# Addendum 1

# City of Canton, Ohio

| Playground Equipment Instal  | lation at Cornelia, Crenshaw, Garaux a | and Harmont Parks |

Drawing Name: TCANTON-CORNELIA-R

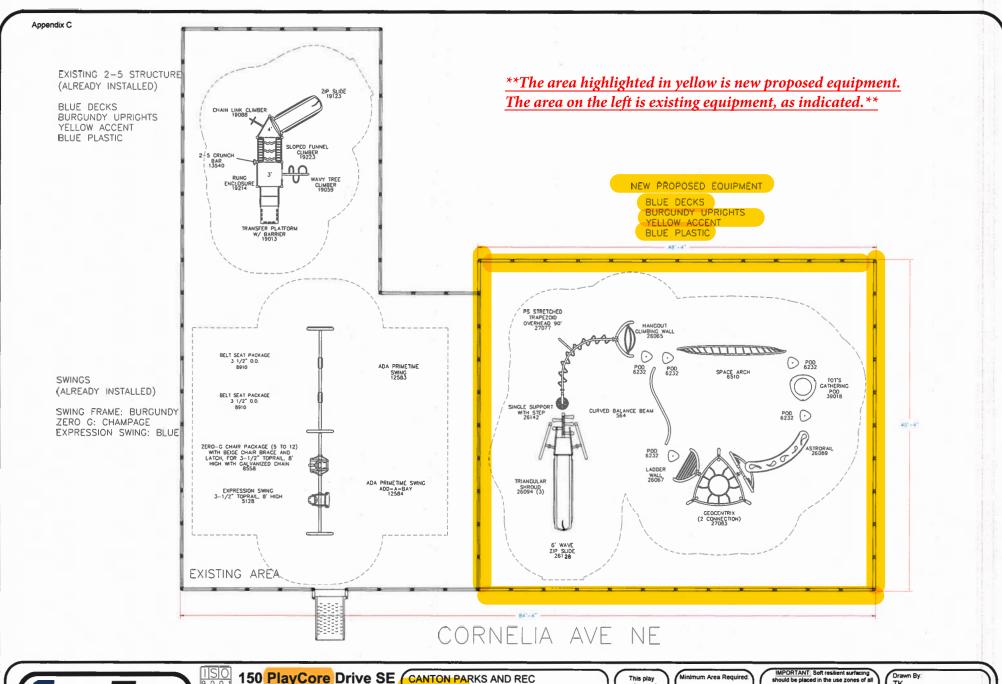
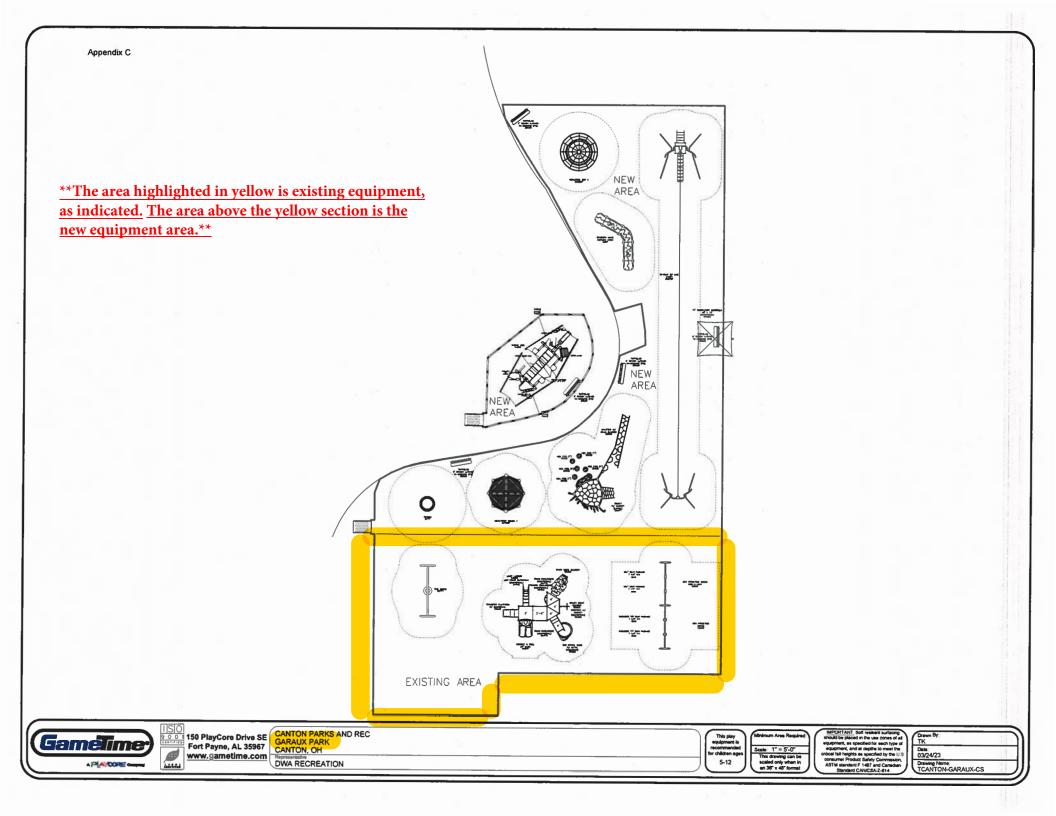
Cornelia Park – need square feet, number of borders, EWF CY?

Cornelia Park-project is approximately 1,920 sf. Borders needed are 4' sections around the play area. 95 EWF CY. The attached drawing shows the new play area highlighted in yellow.

\*\*The area highlighted in yellow is existing equipment, as indicated.

The area above the yellow section is the new equipment area\*\*

Crewn By:
TK
Cuts
0,322/23
Drawing Name:
T CANTON-HARMONT

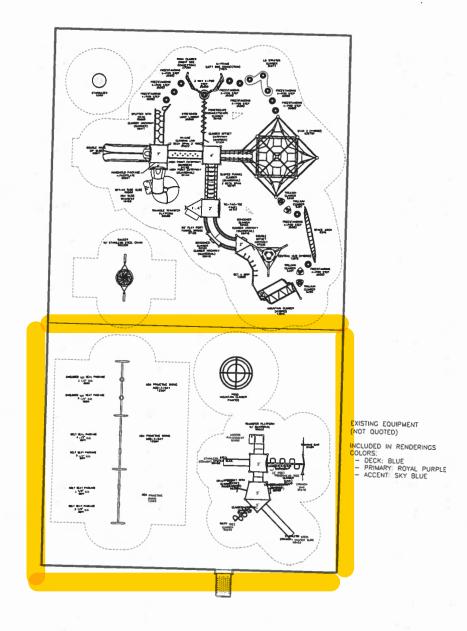
Harmont Park- need square feet, number of borders, EWF CY? Also, which items are to be new pieces of play equipment?

Harmont Park-project area is approximately 3,808 sf. 229 EWF CY. Borders needed are 4' sections around the play area.

The attached drawing shows the existing play area highlighted in yellow.
